Georgia Power Company
40 Inverness Center Parkway
Post Office Box 1295
Birmingham, Alabama 35201
Telephone 205 877 7122

January 8, 1993

Docket Nos. 50-424
50-425

VOGTLE ELECTRIC GENERATING PLANT
DIFFERENTIAL SETTLEMENT OF BURIED PIPE

SOUTHERN COMPANY SERVICES, INC. BIRMINGHAM, ALABAMA	
GEORGIA POWER COMPANY ALVIN W. VOIGTLE NUCLEAR PLANT	
PENETRATION DETAILS OF SAFETY RELATED BURIED PIPING ENTERING CATEGORY 1 STRUCTURES	
SCALE: NONE	SHEET NO.
DATE: 10/10/64	SR-A-SMP-002
REVISED	A

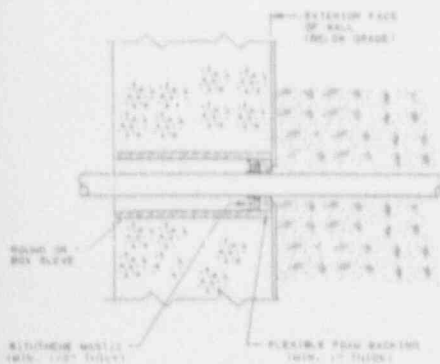
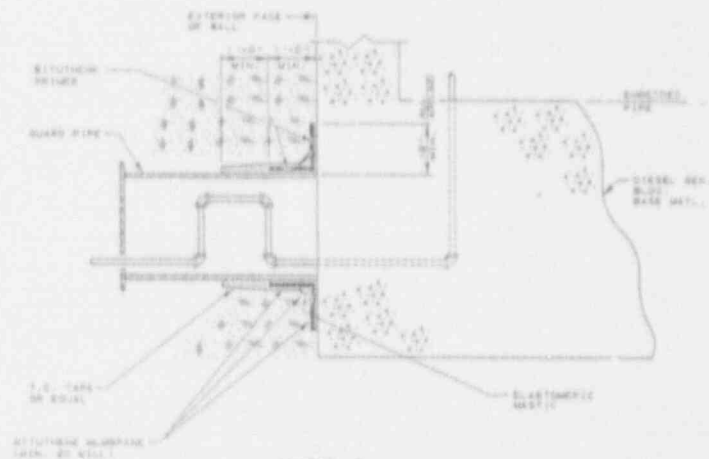
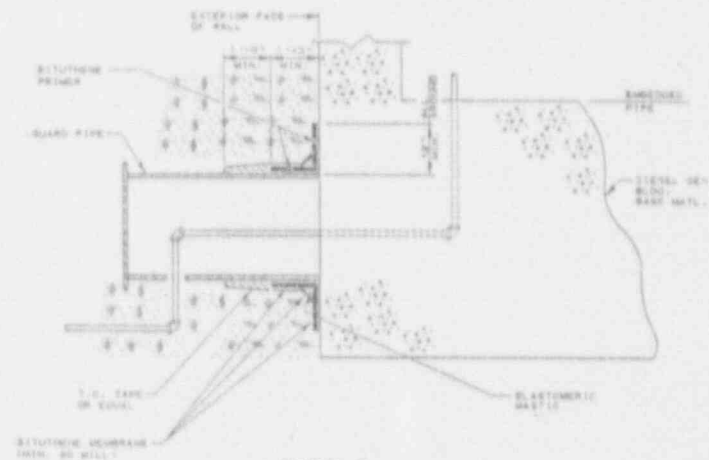
By comparison, a total of only 38 safety related buried pipes interface between compacted backfill and Category I structures. (See attached sketch SK-A-SMP-002 for penetration details.) The differential settlement experienced by buried piping is not addressed by the VEGP settlement monitoring program; therefore, no survey points exist in the backfill free field for collecting data regarding changes in backfill elevations. In the absence of this data, GPC has taken the most conservative approach (assuming zero settlement of the backfill) in the evaluation of these 38 buried pipe lines to address the staff's concern regarding the validity of the piping analysis.

SETTLEMENT MONITORING PROGRAM

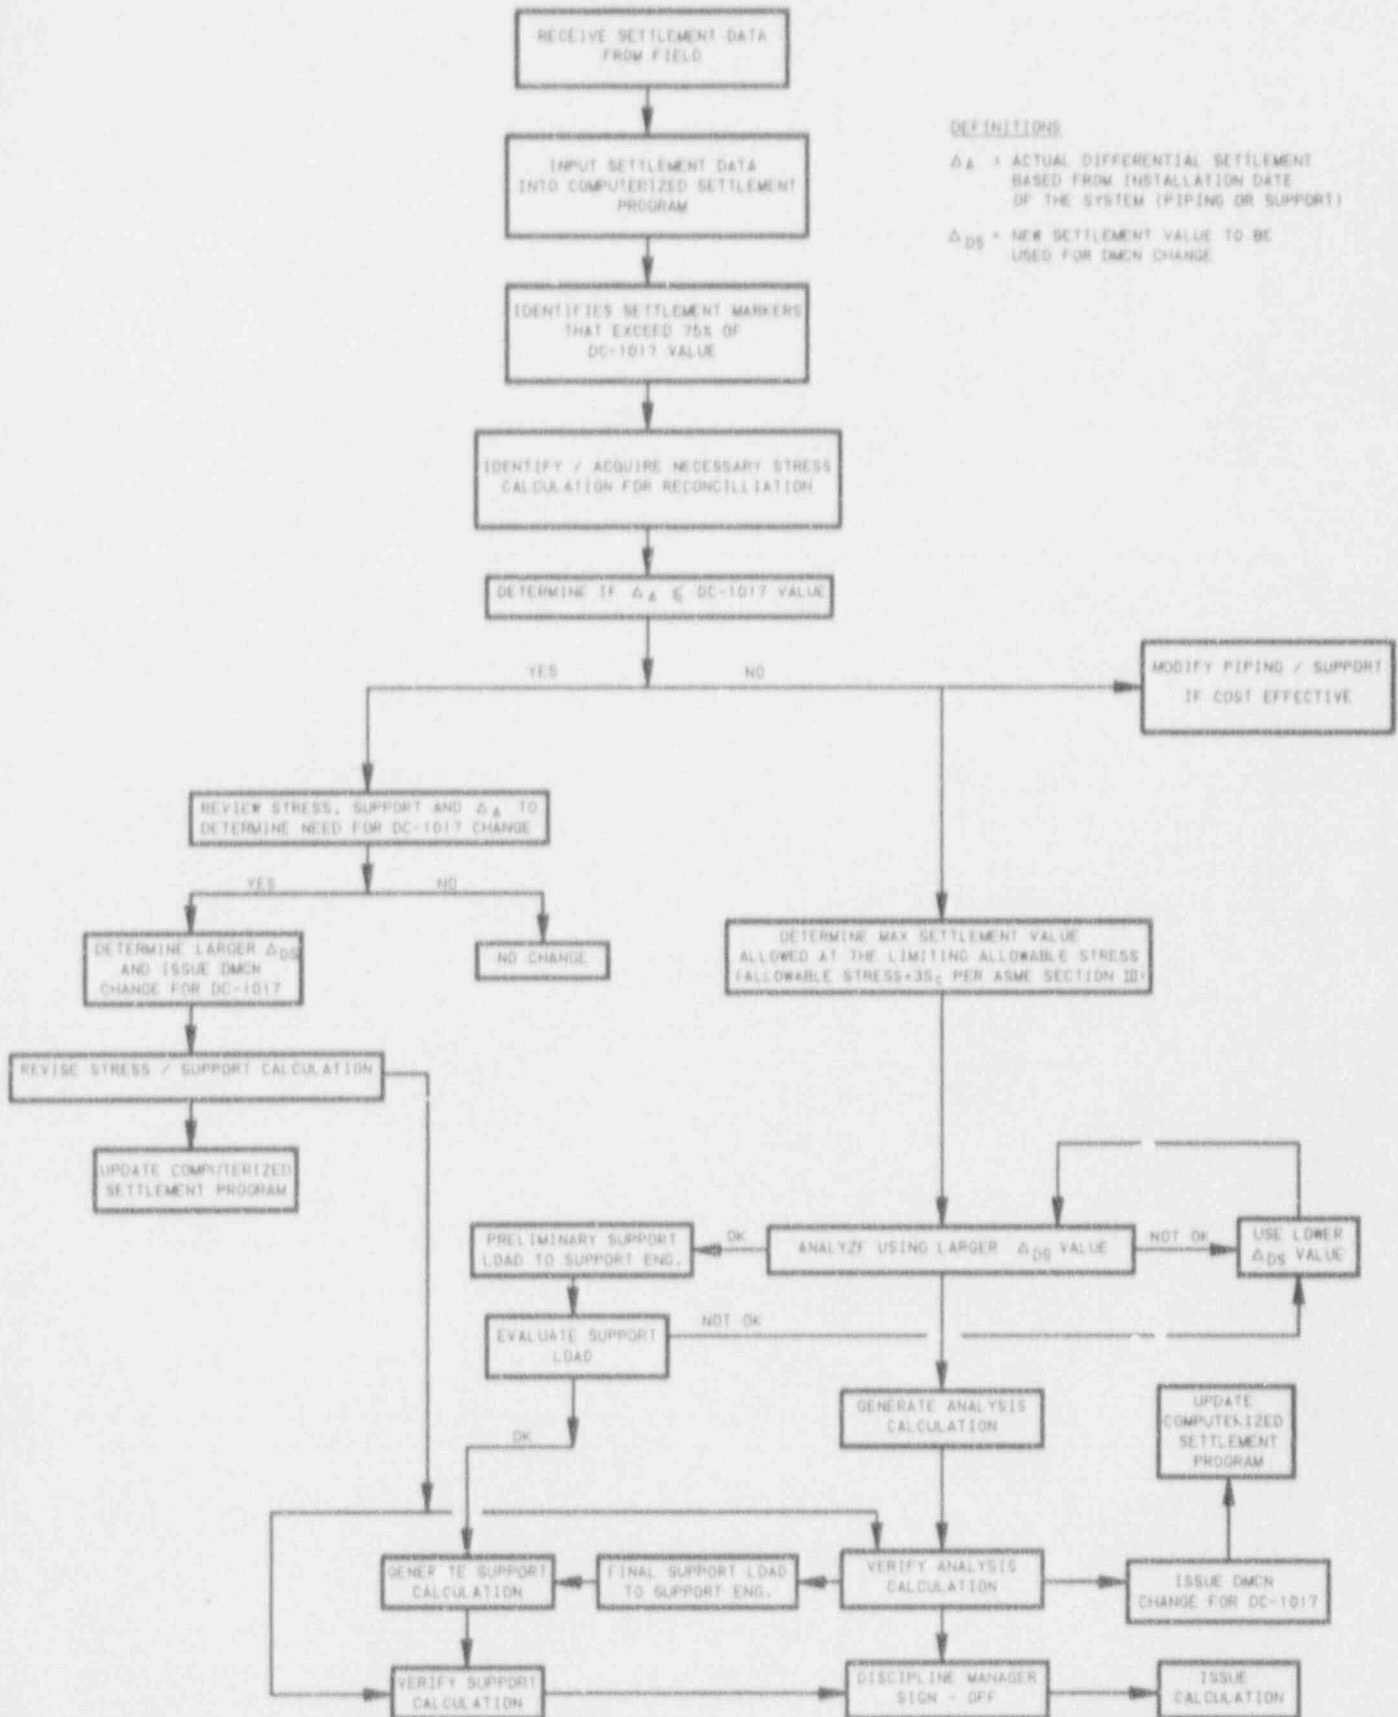
An evaluation of all these safety related buried pipes was conducted as indicated by the attached Settlement Monitoring Program Flow Chart. Table 1 (attached) summarizes the results of the evaluation which was conducted. The following are the assumptions used in the evaluation.
